18/02869/LBC

**Chester House
High Street
Fairford
Gloucestershire
GL7 4AD**

Item No 07:-**Re-roofing of back slope to main house at Chester House High Street Fairford
Gloucestershire GL7 4AD**

Listed Building Consent 18/02869/LBC	
Applicant:	Mr & Mrs M Lee-Browne
Agent:	Michael Grosscurth (Surveys) Ltd
Case Officer:	Mark Smith
Ward Member(s):	Councillor Andrew Doherty
Committee Date:	12th December 2018
RECOMMENDATION:	REFUSE

7. Retained original truss

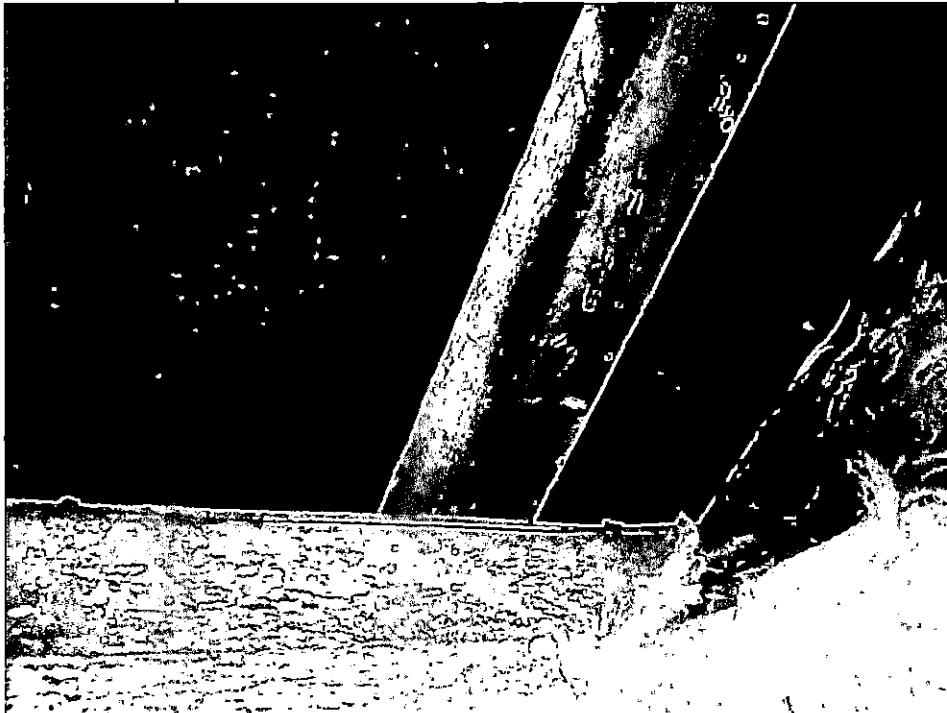
- Packed out and historically lifted
